Proposal for amendments to Regulation No. 55 (Mechanical couplings)

Submitted by the Chair of the informal group on Regulation No. 55

The text reproduced below was prepared by the experts of the informal group on UN Regulation No. 55 and introduces amendments on:

- (a) Applications in multi-vehicle combinations

Figure 1
Dimensions of the centre axle trailer

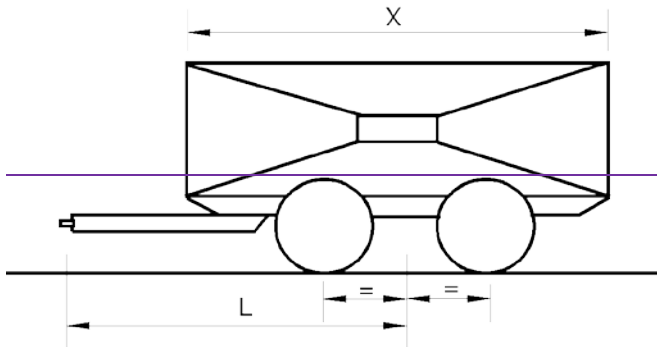
“2.11.4. ~~The V value is the theoretical reference value of the amplitude of the vertical force imposed on the coupling by the centre axle trailer of technically permissible maximum mass greater than 3.5 tonnes. The V value is used as the basis for vertical forces in the dynamic tests.~~

$$\del V = \frac{a \cdot C \cdot X^2}{L^2} \text{ (See the Note below)}$$

X — is the length of the loading area of the trailer, in metres (see Figure 1)

L — is the distance from the centre of the drawbar eye to the centre of the axle assembly, in metres (see Figure 1)

Note: $\frac{X^2}{L^2} \geq 1.0$ (If less than 1.0, the value of 1.0 shall be used)

The V value is a characteristic performance value of the amplitude of the vertical force imposed on the coupling by a center axle trailer. This performance value shall be verified as described in Annex 6 of this regulation.”

Figure 27
Dimensions of the center axle trailer

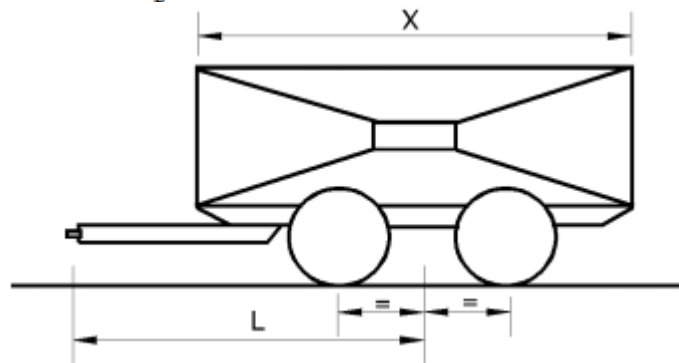
2.2. Vertical forces from center axle trailer

The vertical force imposed on the coupling by the center axle trailer of technically permissible maximum mass greater than 3.5 tonnes is:

$$V = \frac{a \cdot C \cdot X^2}{L^2} \text{ kN} \quad (\text{See the Note below})$$

X is the length of the loading area of the trailer, in meters (see Figure 27)

L is the distance from the center of the drawbar eye to the center of the axle assembly, in meters (see Figure 27)

Note: $\frac{X^2}{L^2} \geq 1.0$ (If less than 1.0, the value of 1.0 shall be used)
